Consumers
Power
Company

March 23, 1976

DOCKET 50-255, LICENSE DPR-20
PALISADES PLANT, CORRECTION TO XN-76-4 AND
ANSWER TO NRC QUESTION ON POSTULATED BROKEN
LOOP ACCUMULATOR FLOW BEHAVIOR FOR 1.0 DEG/PD CASE

FIGURE 1 PALISADES BROKEN LOOP ACCUMULATOR
FLOW DEG/PD $C_D = 1.0$ BASE CASE
AND REANALYSIS

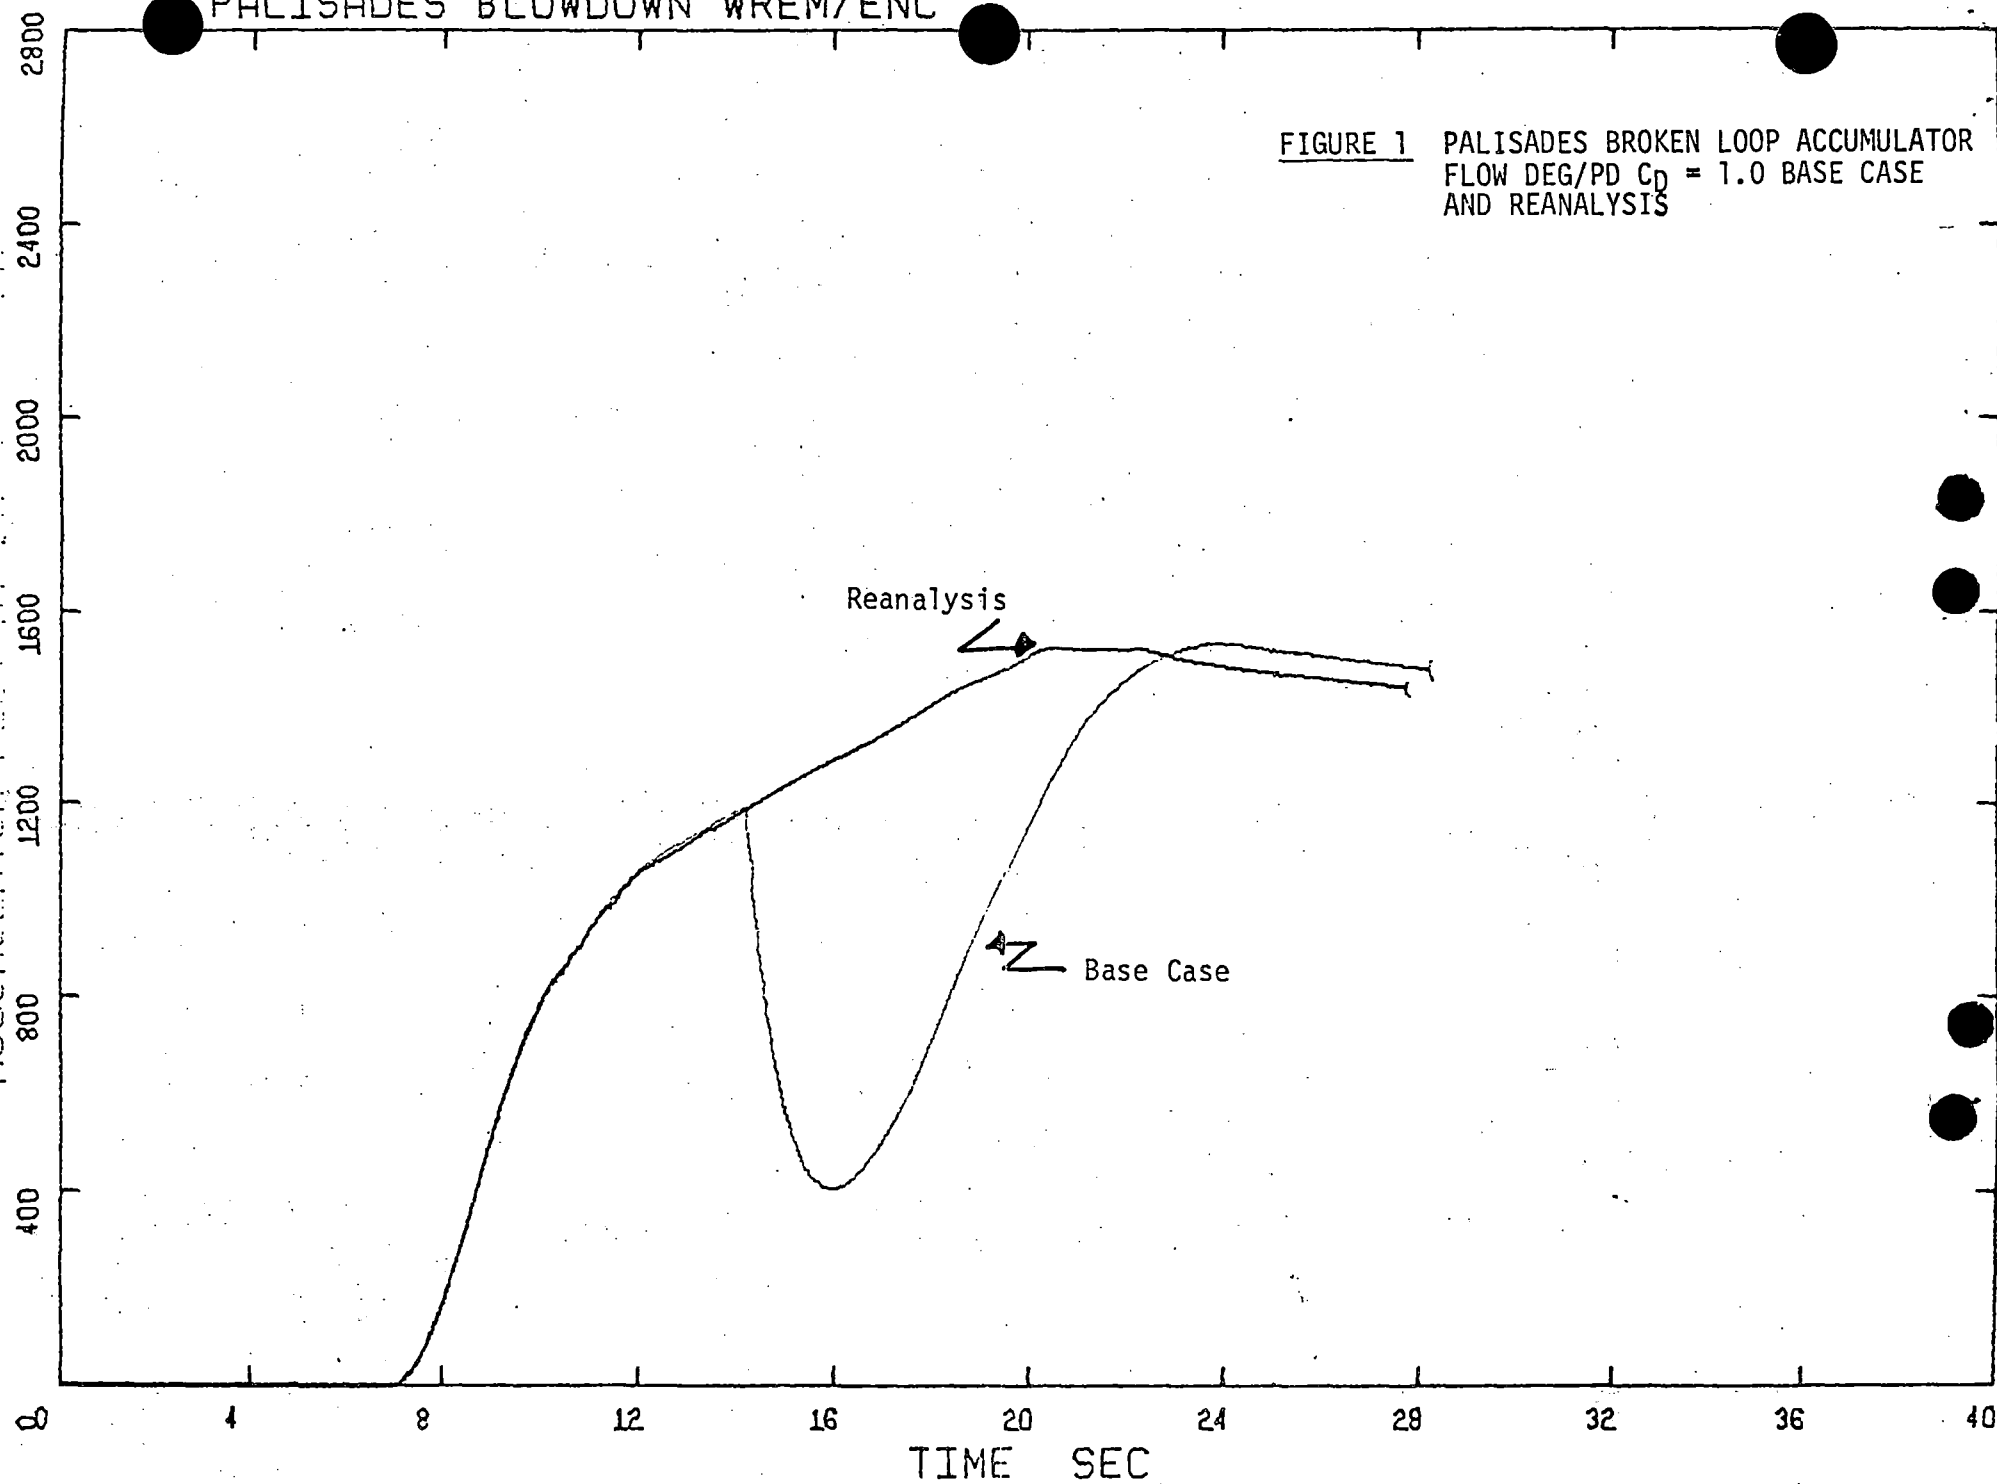
In a telephone conversation March 1, 1976, the NRC staff requested an explanation for the sudden decrease in calculated core flooding tank flow rate for the accumulator connected to the broken loop for the DEG/PD case with $C_D = 1.0$ as shown in Figure 2.48 of XN-76-4. The cause of the sudden decrease was determined to be a pressurization of the break volume due to an inadvertent trip signal which opened the valve between the guillotine break volumes on a restart at 14.2 seconds.

Results of the blowdown calculation compared to the base case originally submitted are attached and results from the TODDEE2 calculation are also given (Figures 1 through 6.) The calculated change from the base case is shown to be minor except for the broken loop accumulator flow rate which is calculated to go out the break anyway. End-of-bypass was calculated at 27.77 seconds or 0.46 seconds earlier than the base case. A PCT of 2065°F was calculated at 171.7 seconds with a local metal-water reaction of less than 10%. Rupture was calculated at 45.7 seconds. The hot spot temperature is estimated to be

In conclusion, the questioned decrease in accumulator flow was caused by an unintentional opening of the valve between the breaks on restart for the DEG/PD $C_D = 1.0$ case. Additional calculations to determine the effect of this inadvertent trip were performed, and the results are attached (Figures 1 through 6). The trip had only a minor effect on the overall LOCA ECCS Analysis. End-of-bypass was calculated 0.46 seconds earlier and PCT was estimated to increase by 23°F.
